DATE: 11.05.2013

FROM: Bill McDow
 Transportation Planning

■ **PANERA BREAD [Plan review #2]**

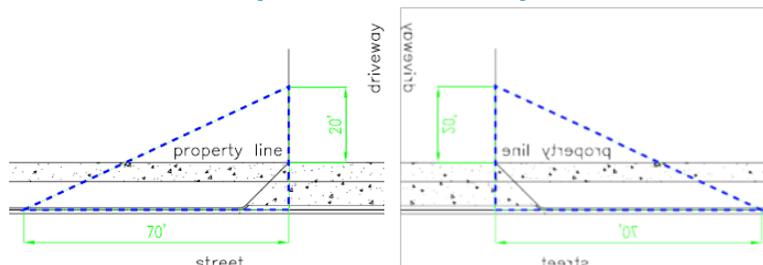
- As previously mentioned, pavement markings on site (SW parking lot) are weathered and may not in be in accordance with the MUTCD standard of maintenance. Additionally, the curb line for this parking area must be adjusted to allow room for the future right turn lane along Independence Blvd. Show the markings as proposed on the site plan.
